# COMMITTEE OF ADJUSTMENT REPORT SUMMARY MINOR VARIANCE APPLICATION FILE NUMBER A043/23 17 SOUTHLAWN DRIVE, WOODBRIDGE

# COMMITTEE OF ADJUSTMENT REPORT MINOR VARIANCE APPLICATION A043/23

17 Southlawn Drive, Woodbridge

ITEM NUMBER: 6.3	CITY WARD #: 2
APPLICANT:	David Viti & Franca Ugolini
AGENT:	Tomasz Goral
PROPERTY:	17 Southlawn Drive, Woodbridge
ZONING DESIGNATION:	See Below
VAUGHAN OFFICIAL PLAN (2010) DESIGNATION:	Vaughan Official Plan 2010 ('VOP 2010'): "Low-Rise Residential"
RELATED DEVELOPMENT APPLICATIONS:	None
PURPOSE OF APPLICATION:	Relief from the Zoning By-law is being requested to permit a proposed cabana and covered deck.

DRAWING HILE	CABANA ELEVATION		SOUTHLAWN	RESIDENCE	17 SOUTHLAWN DRIVE, WOODBRIDGE, ONT., L4H 1A1
	_			_	Ι ≻
	ı	ıl		- 1	ВУ

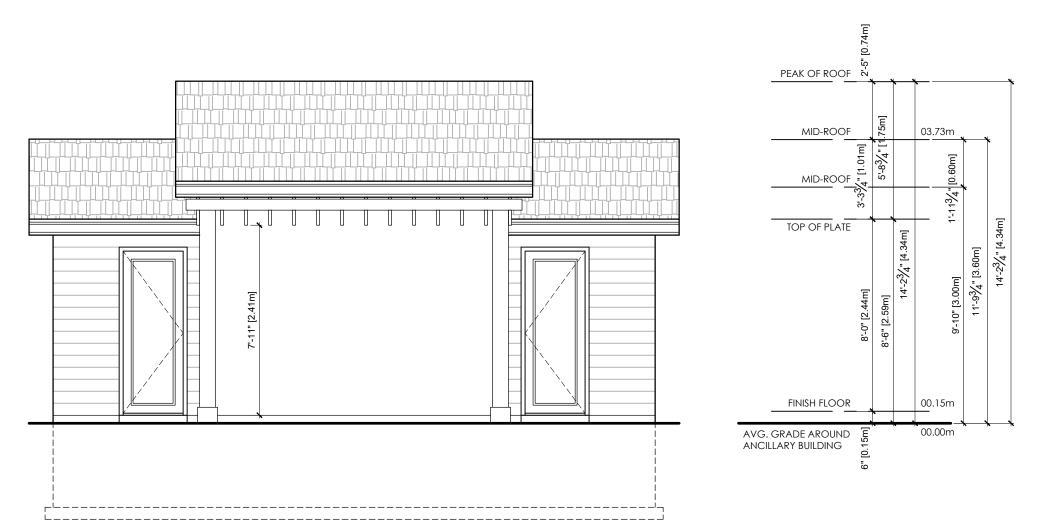
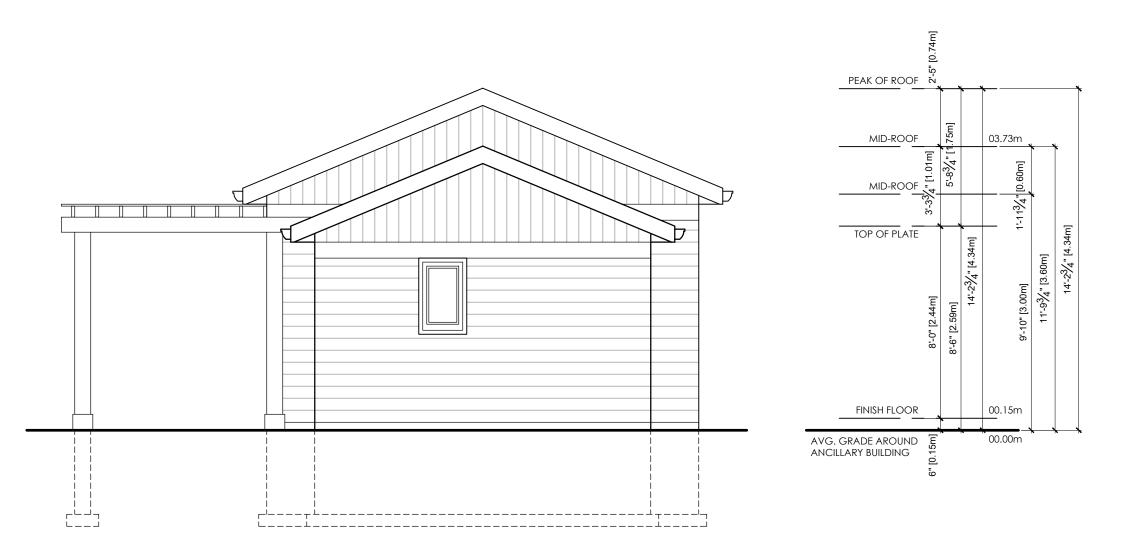
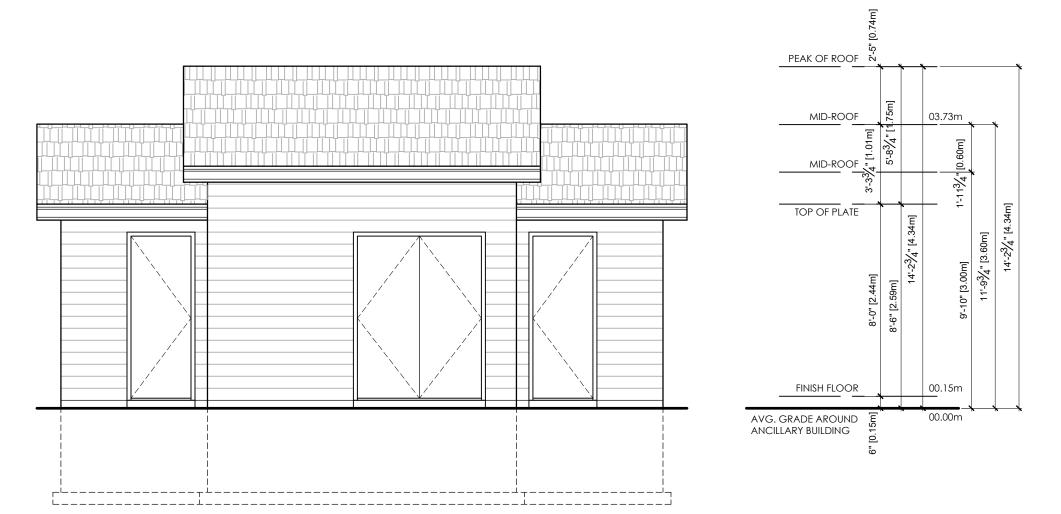
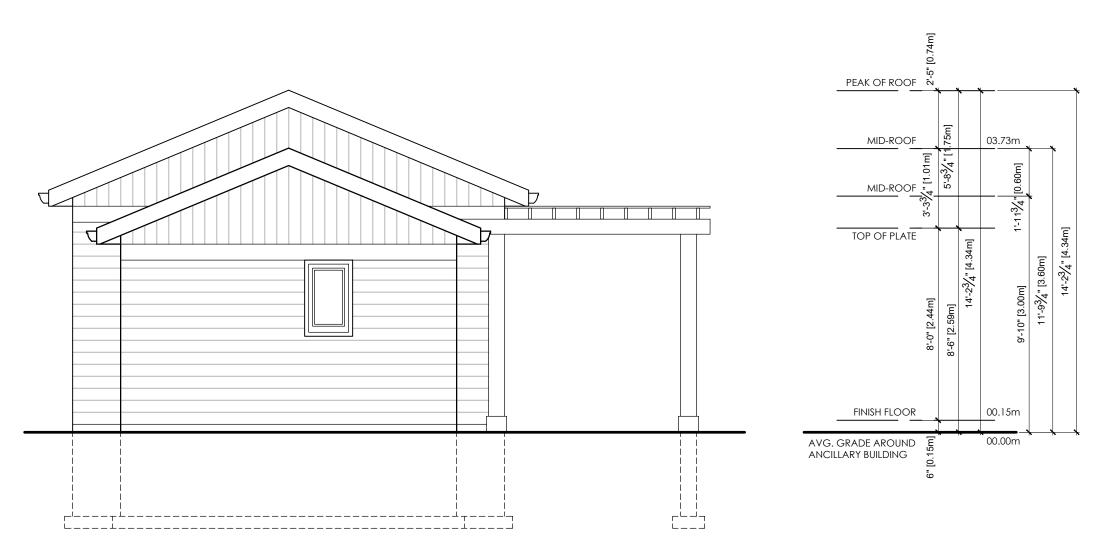
We are fine with the recommendation to reduce the overall height of the cabana. The revised drawing will be completed and submitted on or before next Wednesday, June 14th.	
	On June 14, 2023, the applicant submitted reviews plans and Zoning Review Waiver, reducing height of cabana from 3.73 metres to 3.60 metres.	
Was a Zoning Review Waiver (ZRW) Form	submitted by Applicant: Yes
